Woltz Residence Defect List

HVAC 5 ton Split System - Master Closet Attic Space Inadequate

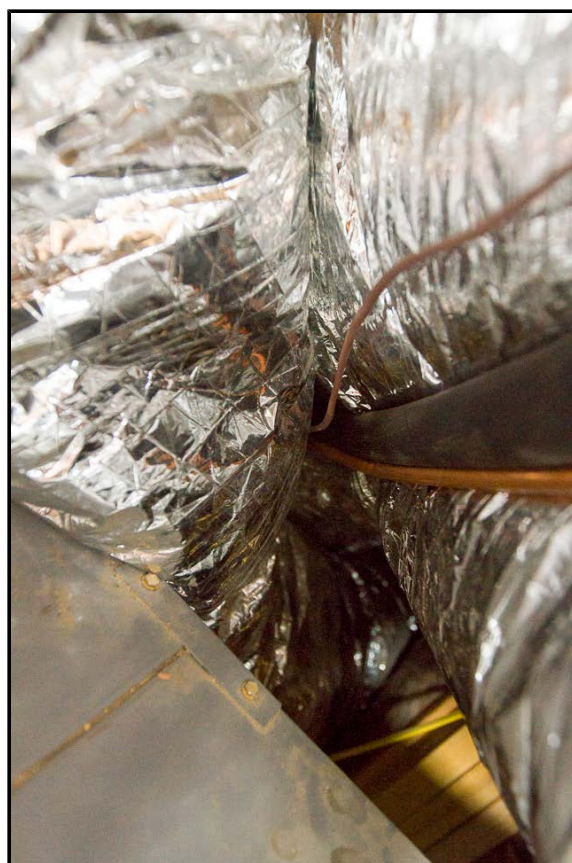
The attic space above master bedroom closet chosen by the contractor for the 5 ton air handler is too small. The 72 x 96 attic space does not provide adequate room to properly run the necessary ducting for a 5 ton unit. Most, if not all, flex-duct located in the master closet attic space is not properly installed.

The 2 supply ducts and return duct are crushed (deformed) beyond industry standards. One 18 inch supply duct is squeezed down to 6 inches and is folded (bent) over the air handler (see photos).

The attic space above the master closet is by no means an ideal location but all other options given to the home owner were rejected. In order to supply adequate spacing for equipment and duct work it would have been necessary to either add back drops, re-truss the house or shadow sky windows. None were acceptable by owner. Again unit is AHRI rated @ 1,750 CFM.

HVAC Sub-Contractor must be confusing another installation with this one. The only accurate, though understated, statement is that "The attic space above the master closet is by no means an ideal location".

We have never been given the opportunity to review options, before or after, the HVAC installation, much less accept or reject them. The chosen list of options "presented" is hyperbole and meant to distract from the real issue that other very practical options did and do exist, but were not considered.

HVAC 5 ton Split System - Incorrect Condensate Drain Traps

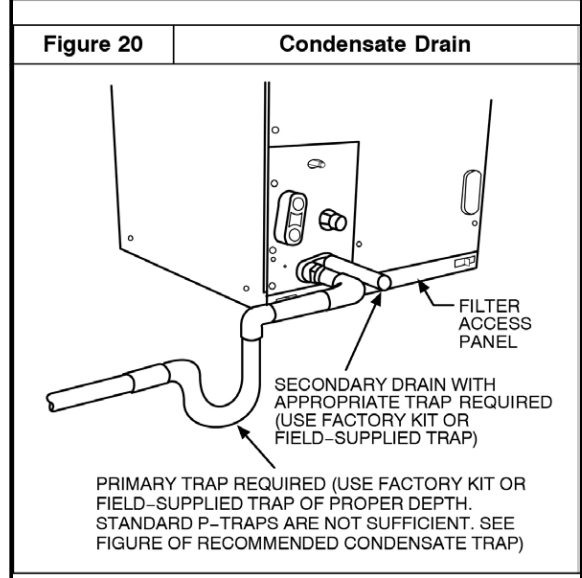
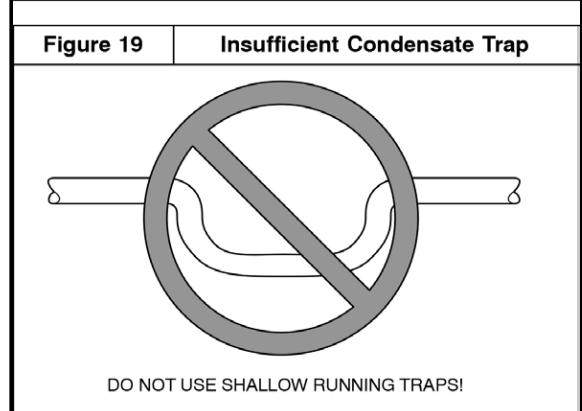
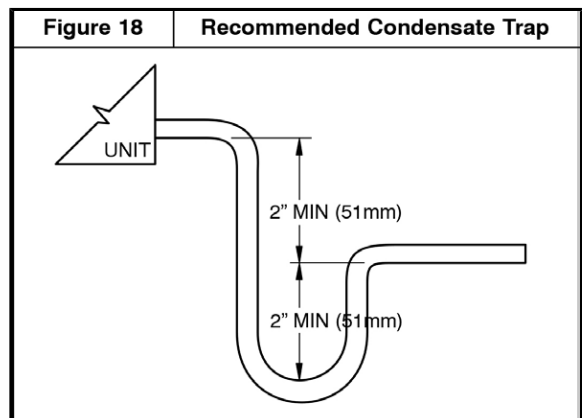
Condensate drain traps of required size and shape were not used. The primary condensate drain uses a trap made from 3 PVC elbows, and the secondary drain has none. Quoting the installation instructions:

- To prevent property damage and achieve optimum drainage performance, **BOTH** primary and secondary drain lines should be installed and include properly sized condensate traps (refer to Figure 18)

- Failure to follow this caution may result in product or property damage. **Use only full size P-traps in the condensate line (refer to Figure 18). Shallow, running traps are inadequate and DO NOT allow proper condensate drainage** (refer to Figure 19). (ICP FEM4X60000b2 Fan Coil installation instructions, Page 14)

Condensate drains will work fine as they were installed and you do not put a trap on the secondary.

The HVAC contractor seems to know better than the equipment manufacturer and mechanical engineers that design the HVAC equipment he installs.

Family Room Fireplace

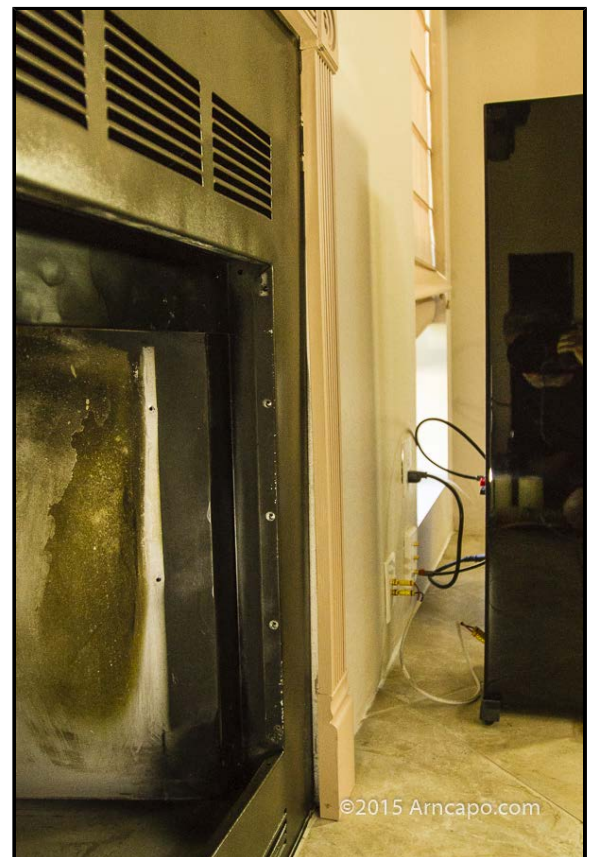
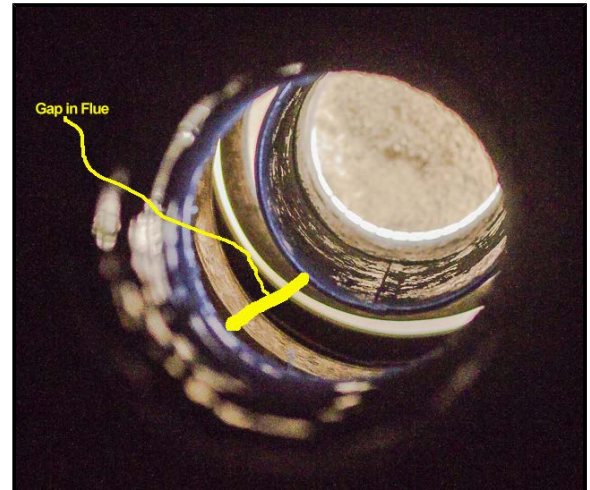
The contractor was paid to lower the family room fireplace firebox to floor level, about 14in. This resulted in a 14in gap in the flue duct and a gap in the flue heat-shield duct. The flue and heat-shield gaps were not repaired by the contractor. Because the structure around the flue is wood 2x4s, wood roof joists, sawdust, construction debris, and insulation, use of the fireplace would almost certainly start the home on fire. Tempe building department has indicated that once it is installed correctly, an inspection is required.

The front of the fireplace was not installed plumb, a vertical deviation of 0.5" over the 36" height of the fireplace firebox front. This makes adding trim very difficult and unsightly.

Electrical

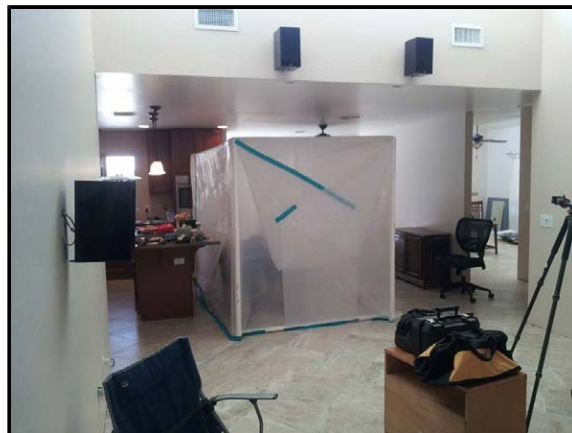
Exterior electrical boxes have been falling out of the wall when unplugging a cord. The failure occurs on the first use indicating an inadequate installation.

The north east exterior flood light is not working.
